**CITY OF RAMSEY LAND USE APPLICATION
TECHNICAL REVIEW FILE**

DATE	OCTOBER 27, 2017	PROJECT ADDRESS	NORTH AND SOUTH OF ARMSTRONG STREET AND WEST OF TIGER STREET NW
PROJECT TITLE	RUM RIVER PRAIRIE SKETCH PLAN		
ESCROW #			
DEPARTMENT:	Community Development: Planning Division (Zoning Code)		
TECHNICAL REVIEWER:	Name: Eric Maass, Consultant City Planner Phone: (763) 576-4306 Email: EMaass@wsbeng.com

We offer the following comments regarding the Sketch Plan submittal for Rum River Prairie as it relates to the City’s Zoning Code. Sketch Plan submittal consists of one (1) sheet, prepared by LHB, Inc. and dated September 25, 2017, and was received by the City on October 2, 2017.

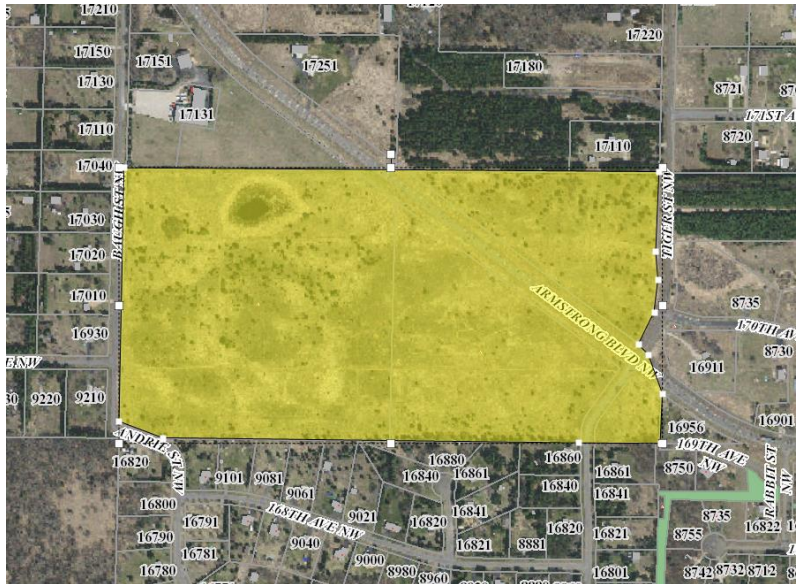
Wetlands. At the time of preliminary plat, the plat sheet will need to show the wetland setback requirement which is 16.5 feet from the edge of the delineated wetland. The wetland setback area in addition to the wetland itself will be required to be encumbered with a drainage & utility easement.
